SRR-CWDA-2019-00028, Revision 0

GENERAL SEPARATIONS AREA GROUNDWATER FLOW MODELING

**Discussion Supporting NRC Onsite
Observation Visit
March 18-19, 2019**

Figure 43. Simulated flow direction in the "lower" aquifer zone, averaged over the aquifer thickness.

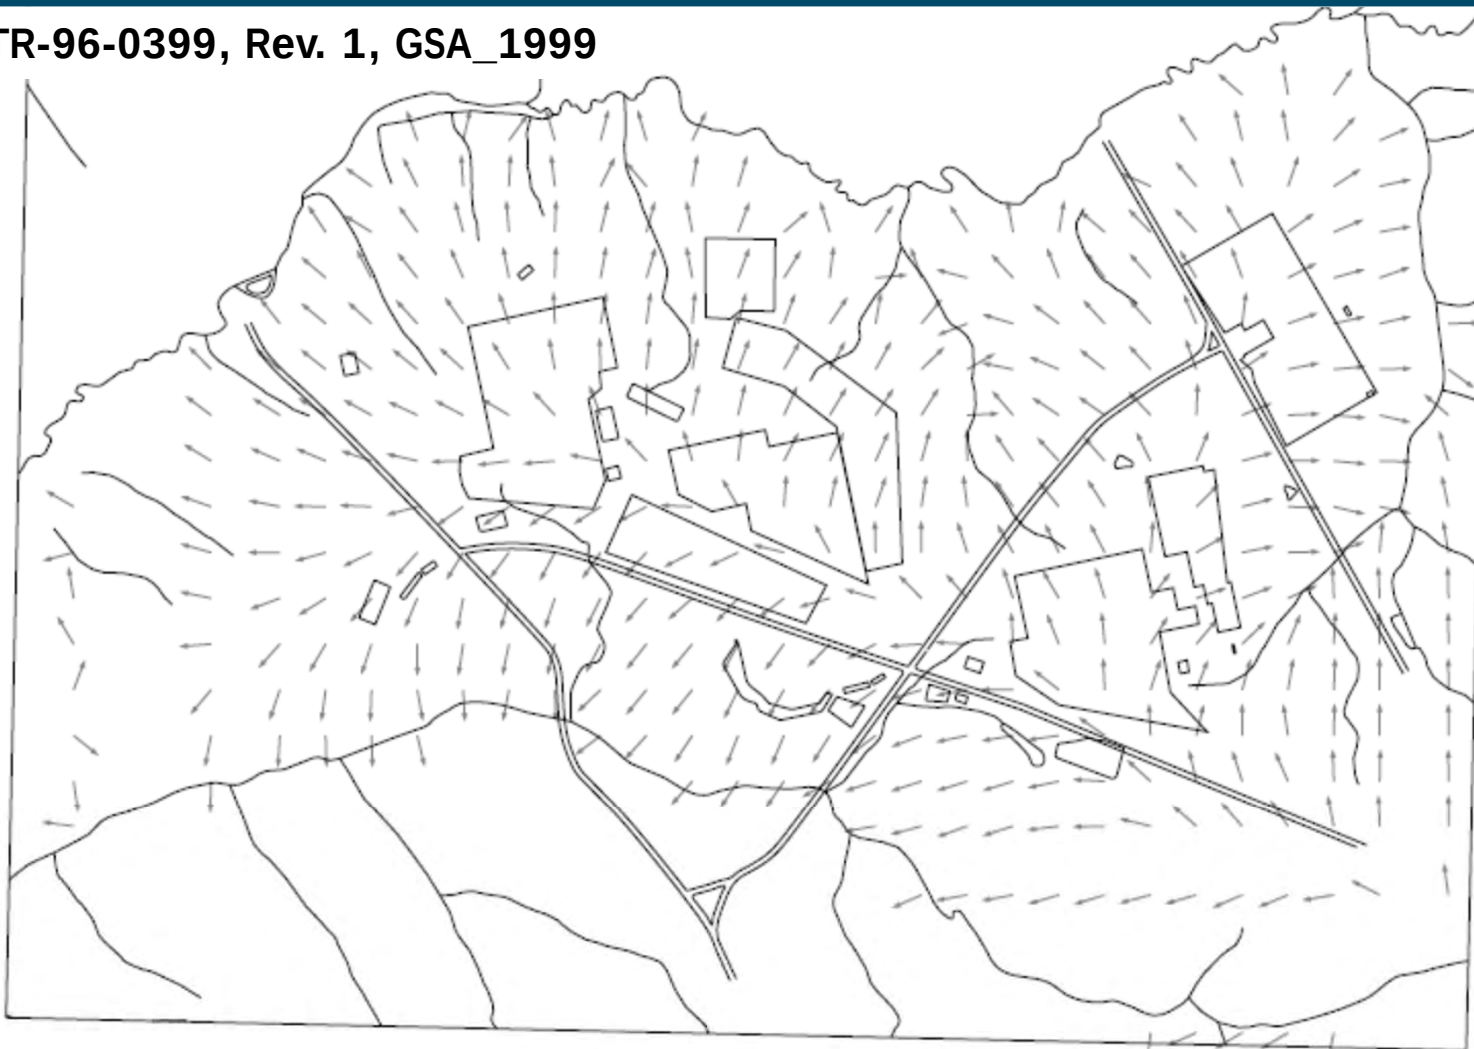
- 1. Stream baseflow (pp. 7-8): Could a map be provided that shows the locations discussed, e.g., Roads A-F, Road 4, Sections 3 & 4.**
[\[Slide 5\]](#)
- 2. Please discuss technical bases for boundary conditions discussed in the section titled “Boundary Conditions” on pp. 11-12 and the figures on p. 75.**
[\[Slides 8-9 in GSA_2004 section for Item 4\]](#)
- 3. Discussion on Figures 43 and 44 and simulated flowpaths from the H Area passing the Crouch Branch.**
[\[Slide 6\]](#)

Figure 2-2. Plan view of GSA/FACT and GSA/PORFLOW computational meshes.

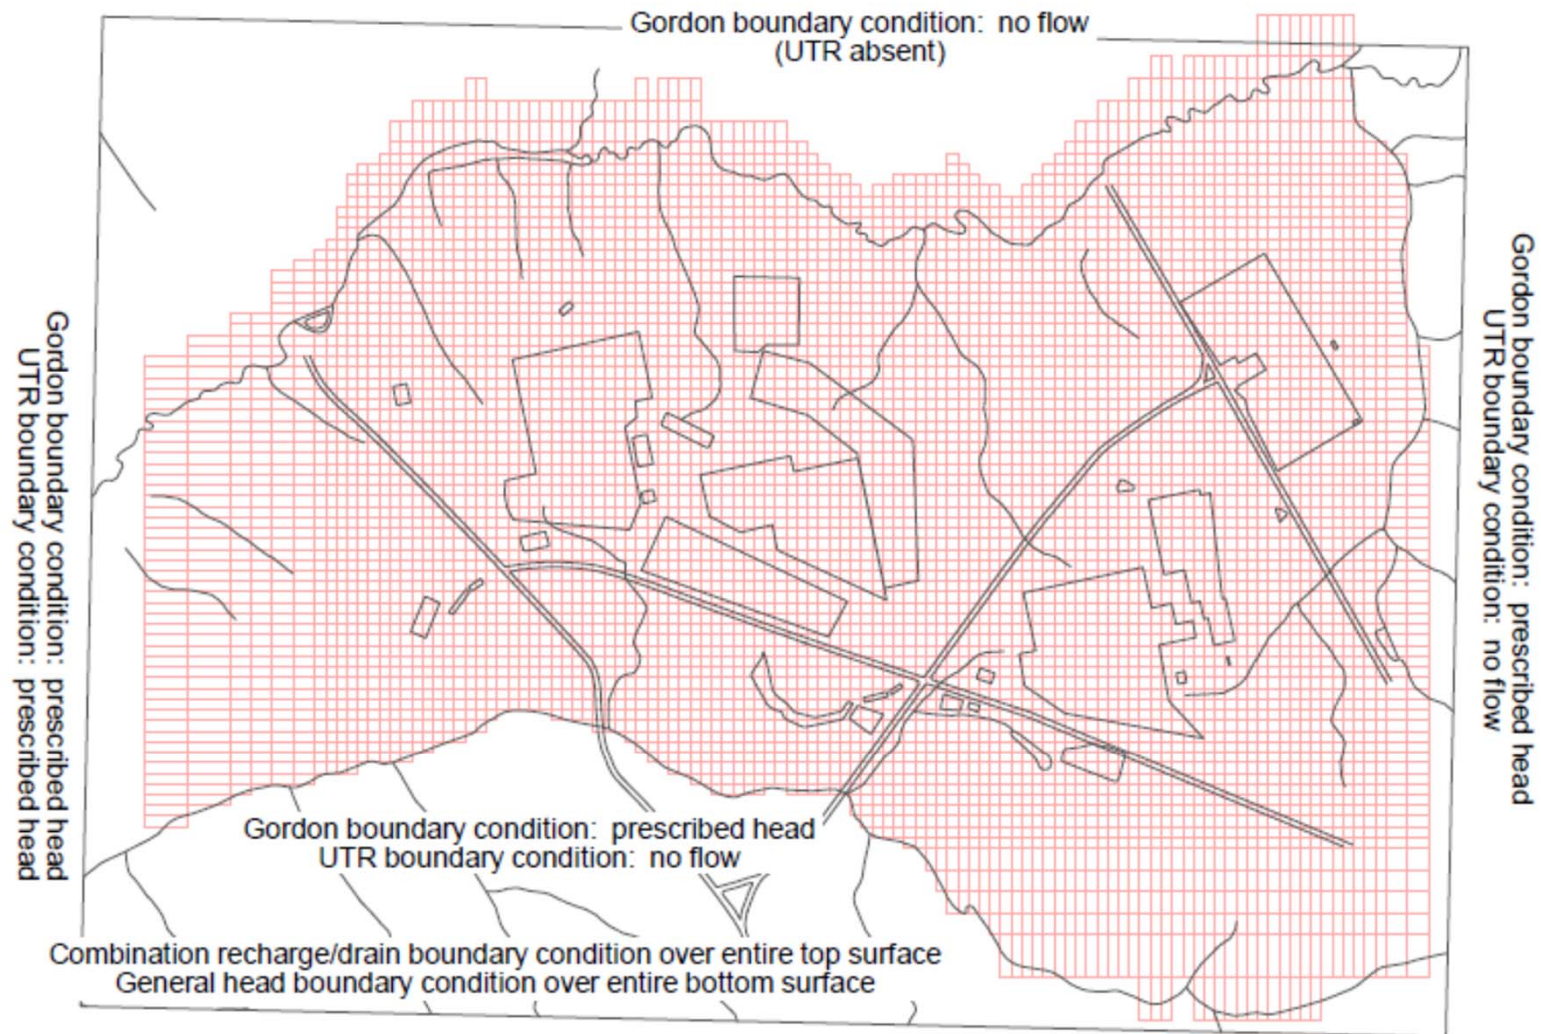
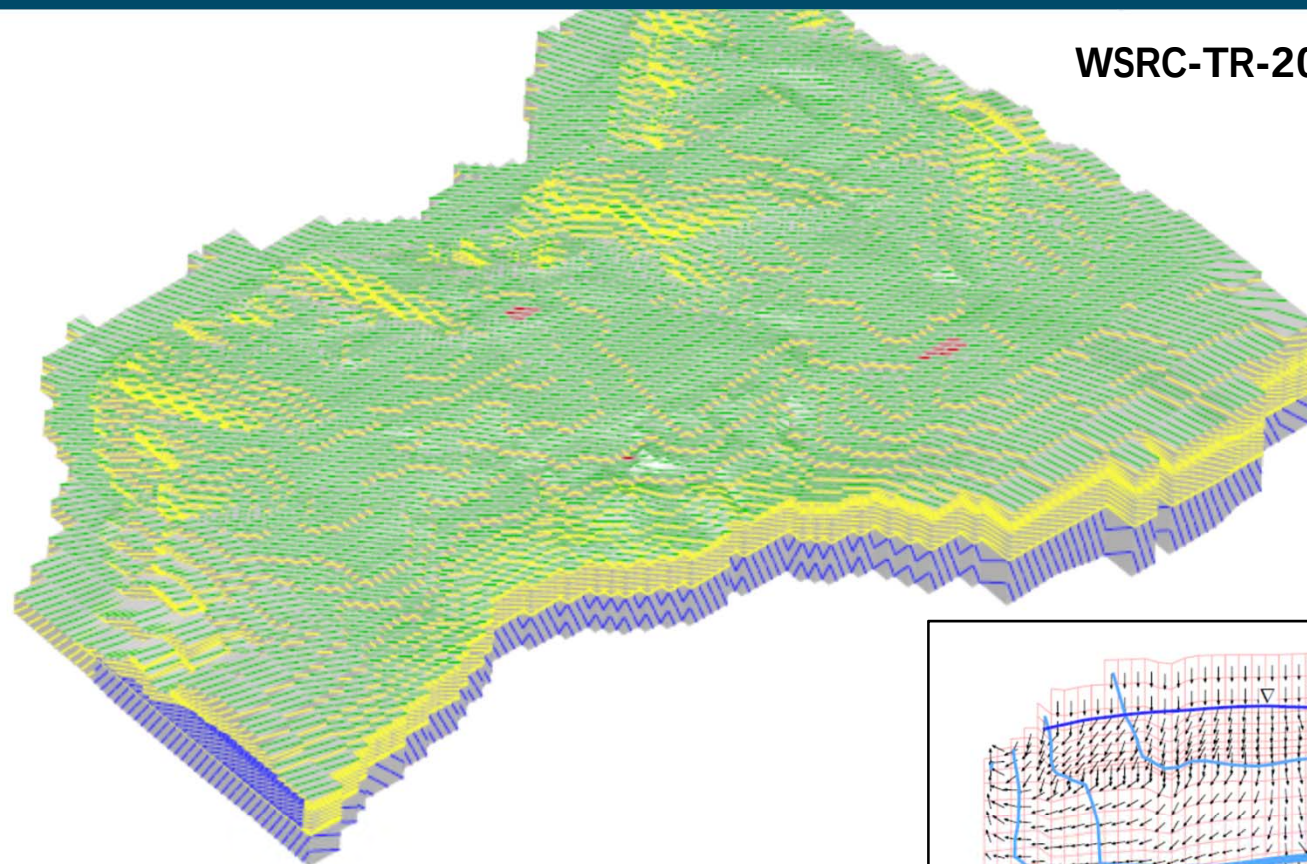
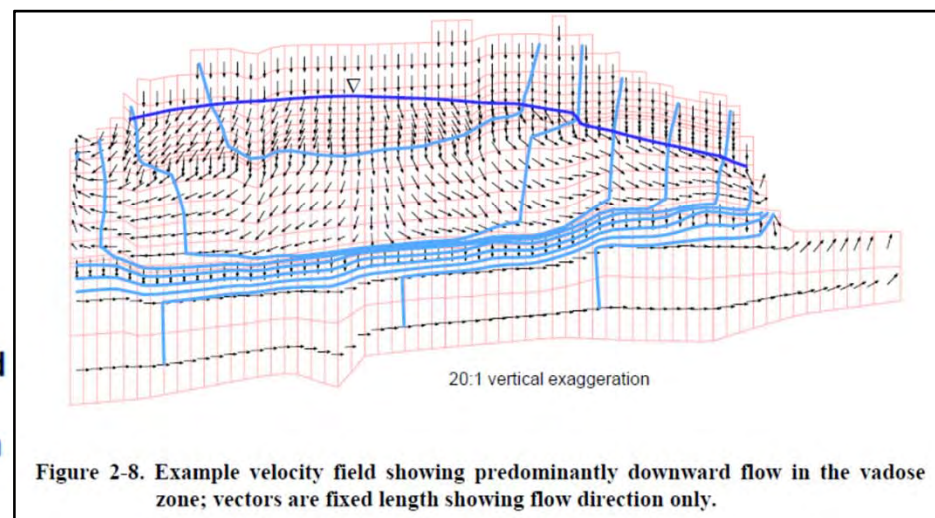
- 4. Discussion and comparison of Figures 2-2, 2-5, and 2-8.
[Slides 8-9]**

SRNL-STI-2018-00336, Rev. 0, Figure 2-1

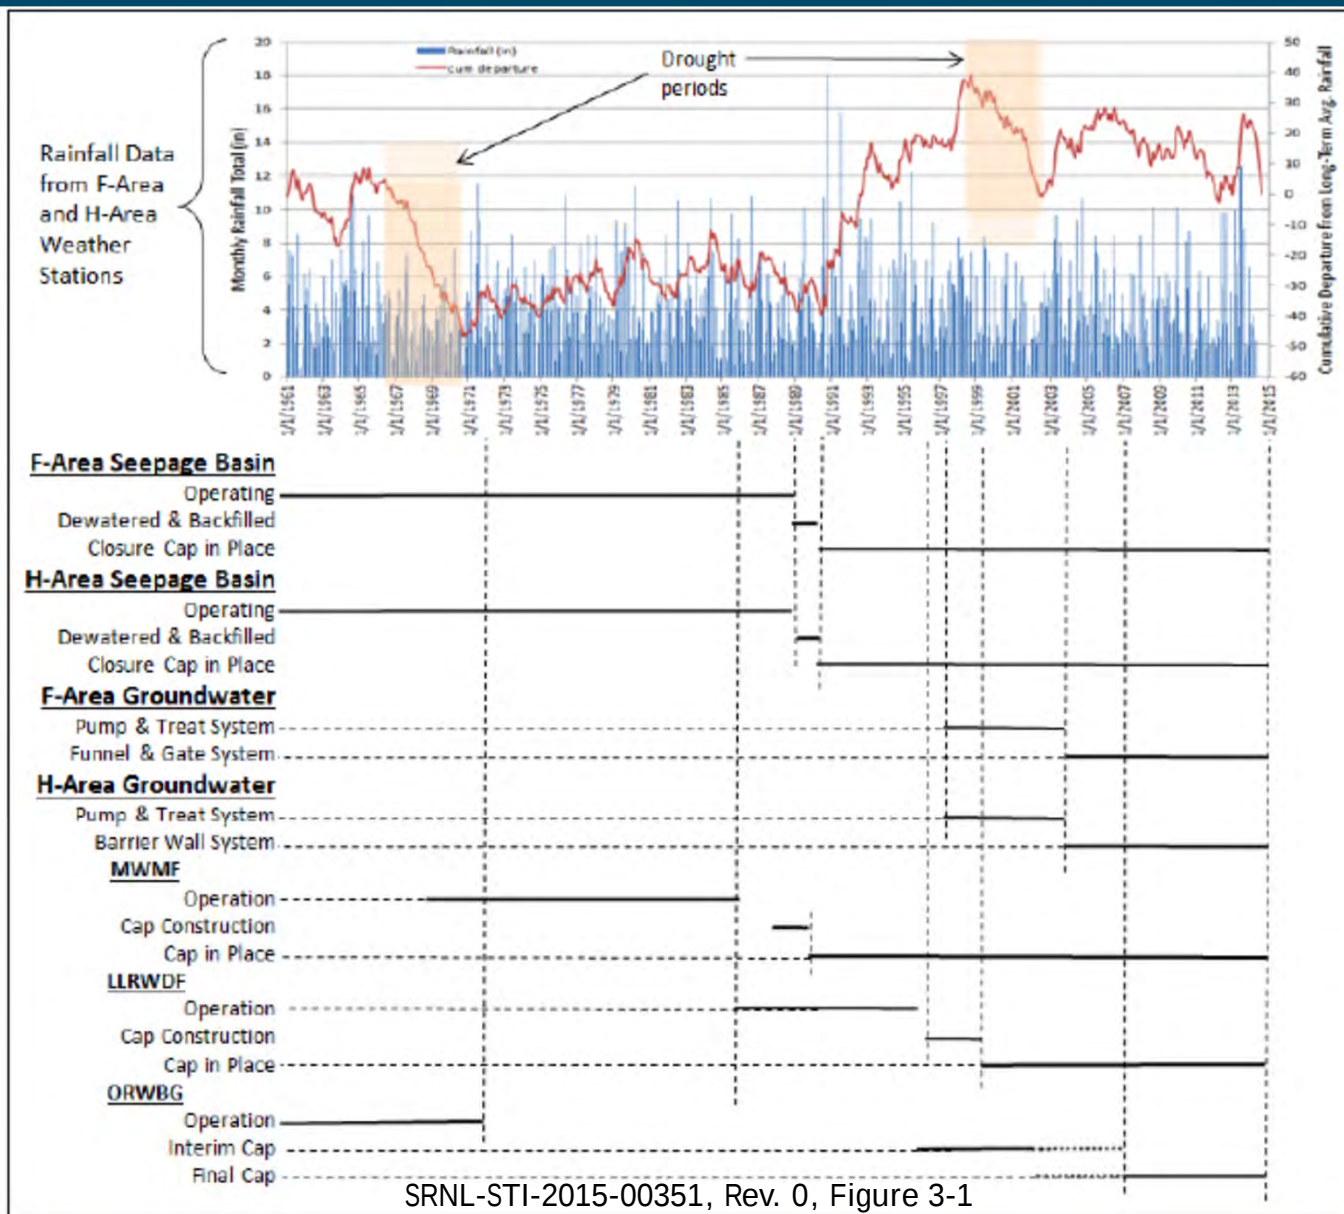
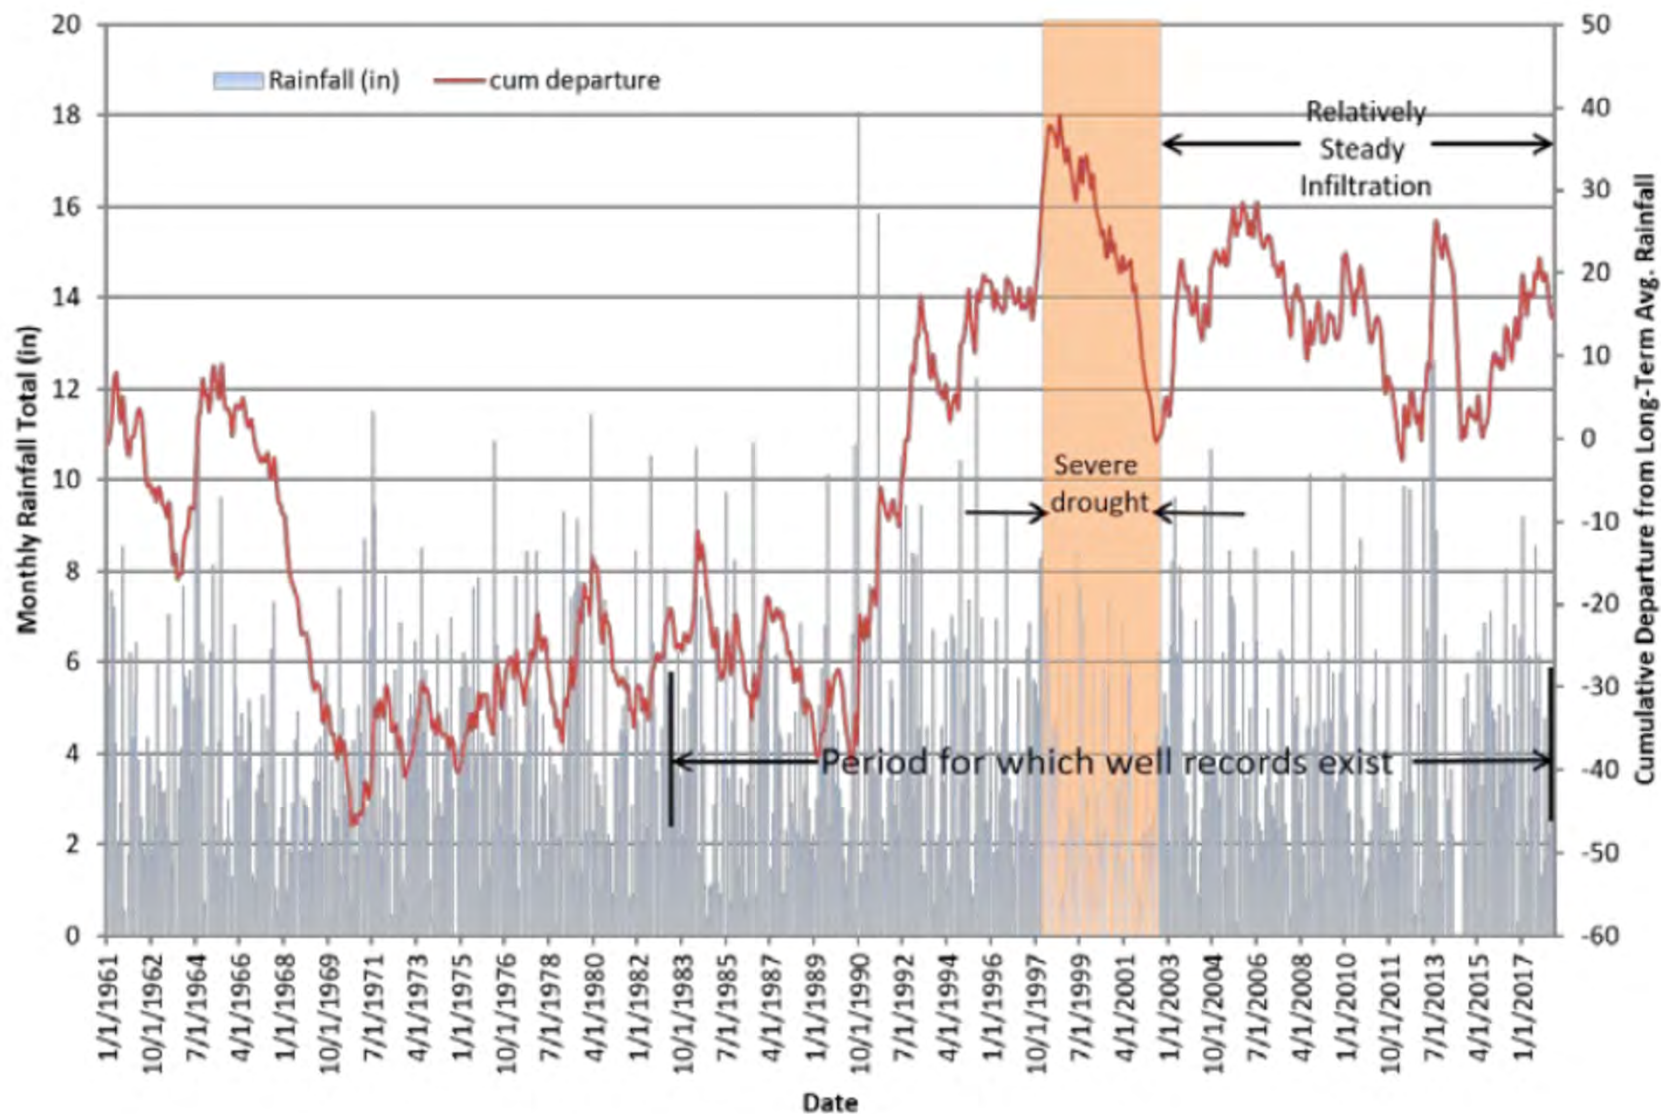
5. Discuss criteria and assumptions stated in the document, e.g., the avoidance of extended time-periods where anomalously low or anomalously high patterns of precipitation occurred.
[\[Slides 11-12\]](#)

2015 Targets: 2004-2014 Average [#5]

2018 Targets: 2004-2018 Average [#5]
